**Item 10.4**
**At Council**
**26 October 2026**

# Relevant Information for Council

| **SUBJECT:** | Information Relevant To Item 10.4 – Public Exhibition - Planning Proposal - 84-86 and 88-94 Parramatta Road, Camperdown - Sydney Local Environmental Plan 2012 and Sydney Development Control Plan 2012 Amendment | | |

## Figure 27. Building envelope - plan

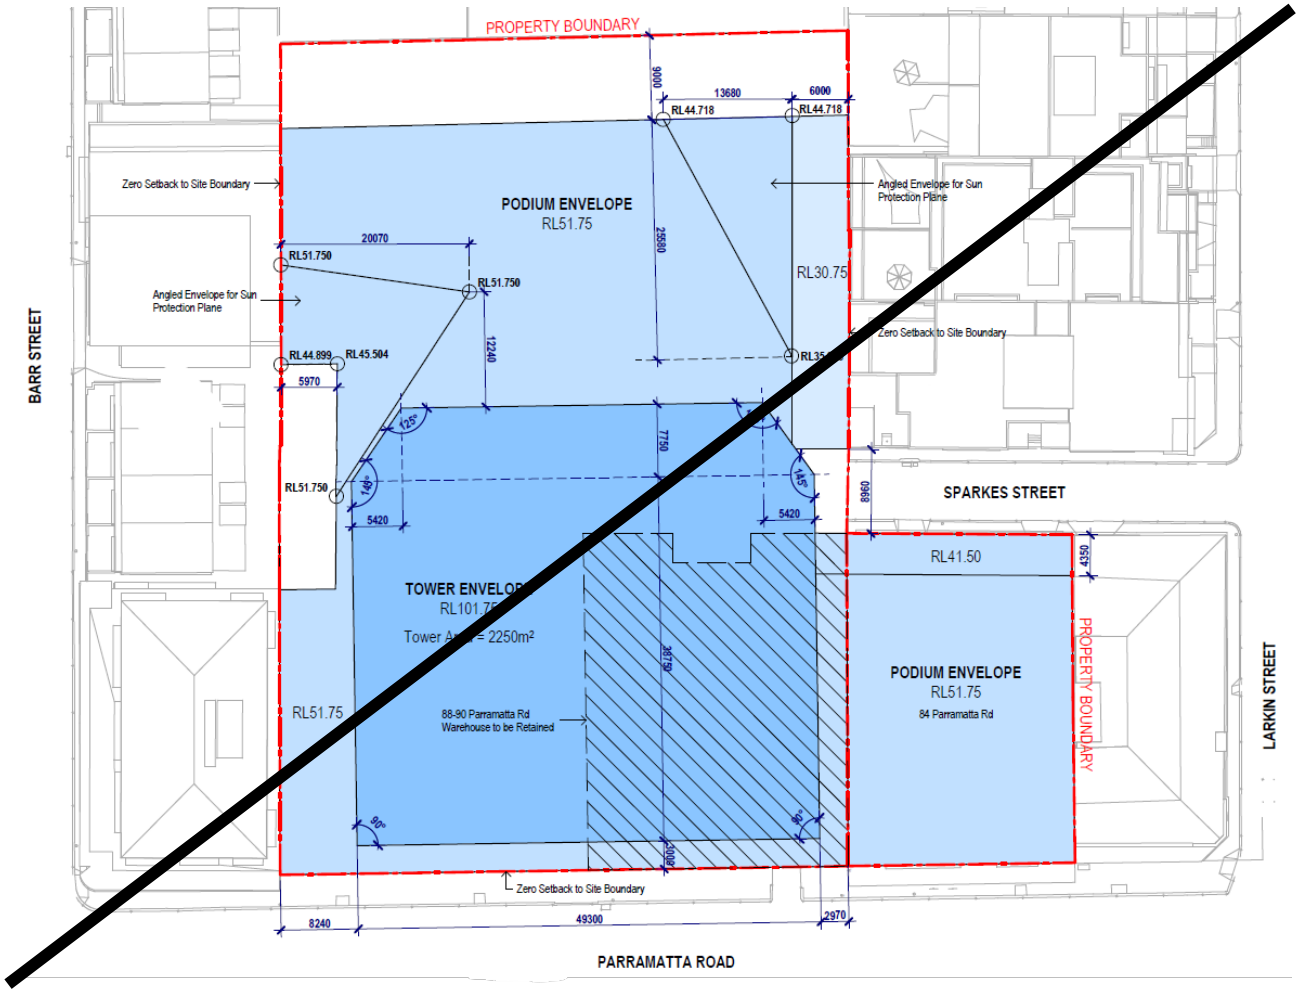
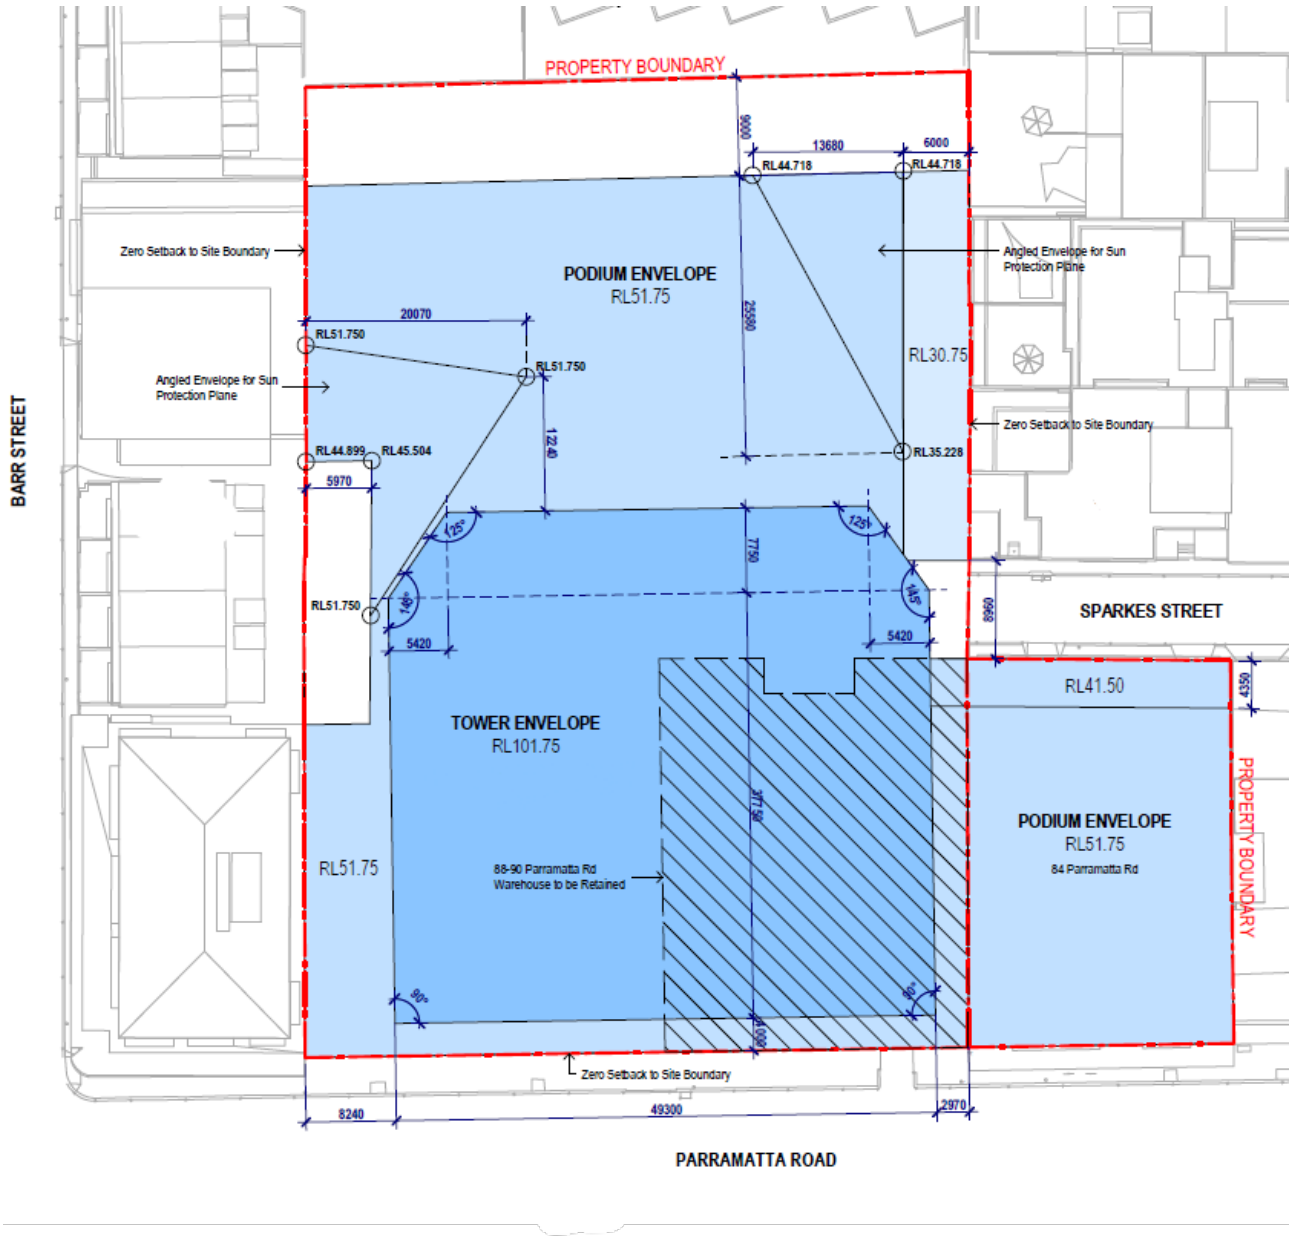
The building envelope, as defined in 'Figure 6.X - Building envelope - plan' in draft Sydney Development Control Plan 2012 - 84-86 and 88-94 Parramatta Road, Camperdown, had previously required a minimum 3 metre setback for the tower envelope from the southern property boundary along the Parramatta Road frontage.

To increase the visual separation of tower and podium, and improve amenity outcomes along Parramatta Road, the minimum setback has been increased from 3 metres to 4 metres. The draft DCP, at Attachment B, has amended the relevant figure and Figure 27 of the planning proposal at Attachment A has also been updated.
